Maule Aircraft Corporation

SERVICE LETTER #38

SUBJECT: Possible float plane reinforcement deficiency.

MODELS AFFECTED: M-5-235C, S/N 7073C thru 7077C, 7079C, and 7085C.

REINFORCEMENT INSTALLATION INSTRUCTIONS

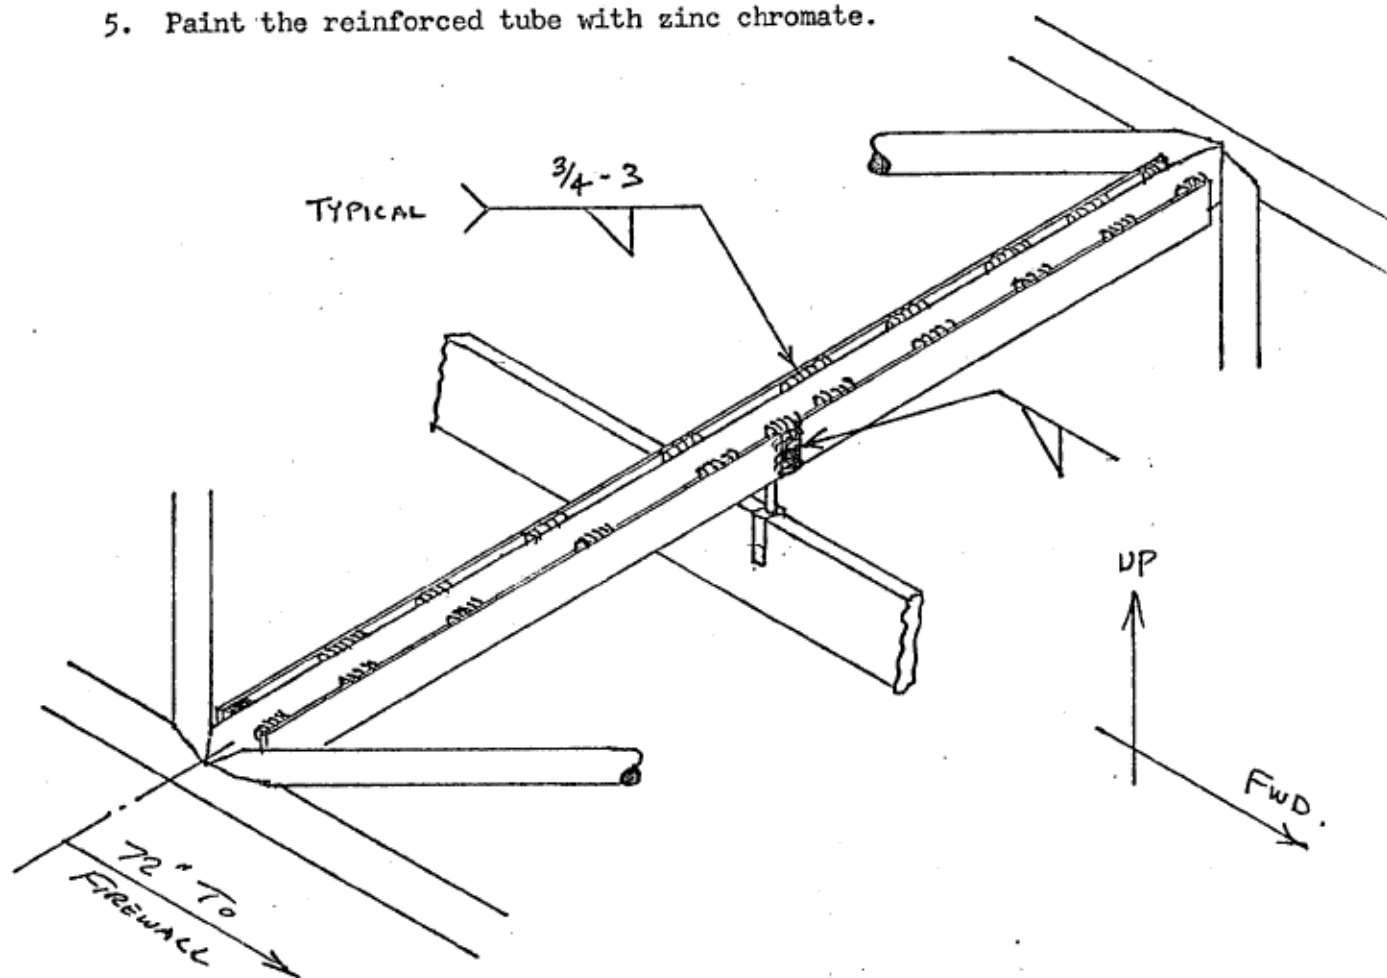
BACKGROUND: There is a possibility that tube #127 (Fuselage bottom, transverse, at the rear/cargo door junction) was not reinforced when the float plane reinforcement kit was installed on these airplanes.

Inspect the subject tube to determine its diameter. The tube in question is on the fuselage bottom, running crosswise, 72 inches aft of the firewall. If this tube is 7/8 inch in diameter, your airplane has the proper reinforcement. So indicate on the Service Letter Compliance Record and return it to us.

If the tube is 3/4 inch in diameter, the float plane reinforcement was not installed on this tube. If you now have the aircraft mounted on floats, you must install this reinforcement before you fly it again.

1. Slide reinforcing tube into fuselage belly below and behind tube to be reinforced, with the channel opening up and the slot forward.
2. Align the slot in the reinforcement with the fabric Stand-off tube and slide the reinforcement up around tube #127, still with the channel opening up.
3. Clamp the reinforcement to the tube and weld both sides of the channel, at the top, to the tube, using a $3/4$ inch fillet weld every three inches.

CAUTION: Spread wet cloths over the fabric in the area being welded, and have a fire extinguisher handy.

4. Weld slot closed.
5. Paint the reinforced tube with zinc chromate.
